ADDENDUM NO. 2

STATE OF MARYLAND
DEPARTMENT OF TRANSPORTATION
STATE HIGHWAY ADMINISTRATION
OFFICE OF TRAFFIC & SAFETY
TRAFFIC ENGINEERING DESIGN DIVISION
MD 28 (W. MONTGOMERY AVE /KEY WEST AVE)
AT SHADY GROVE ROAD
ROCKVILLE, MARYLAND

TRAFFIC SIGNAL PLAN

TS NO. 1189K | DRAWING SG-01 OF 02 | SHEET NO. 1 OF 2

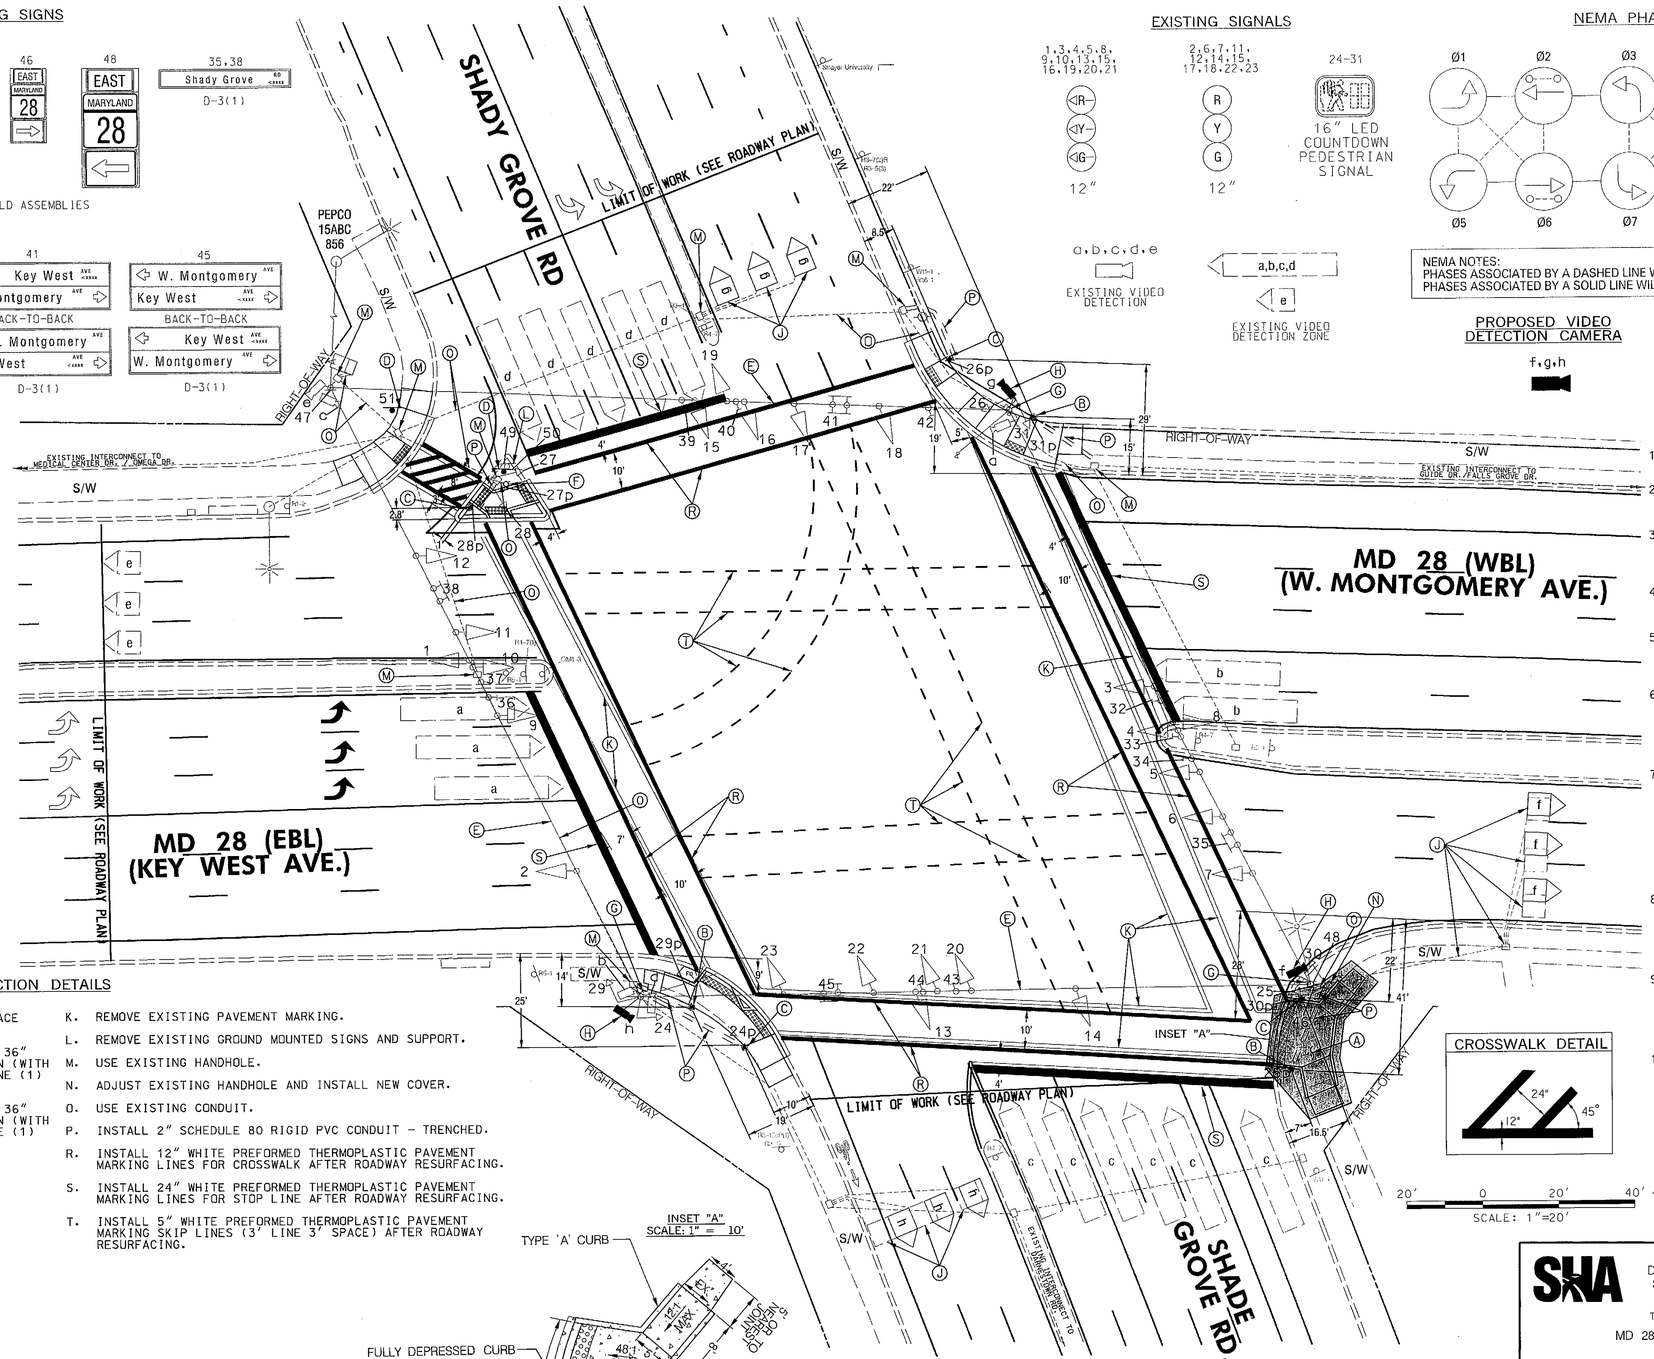
REVISIONS
K INSTALLATION OF APS/CPS AND VIDEO DETECTION CAMERAS TIMS NO. L510 SHA NO. M0131S177; FAP AC-NHPP-G-5010(15)E — APR. 19, 2013
J ADD THIRD LEFT TURN LANE TIM 1410 — 10 FEB 2011
I ADD DOUBLE LEFT TO SB SHADY GROVE RD. — FEB 2006
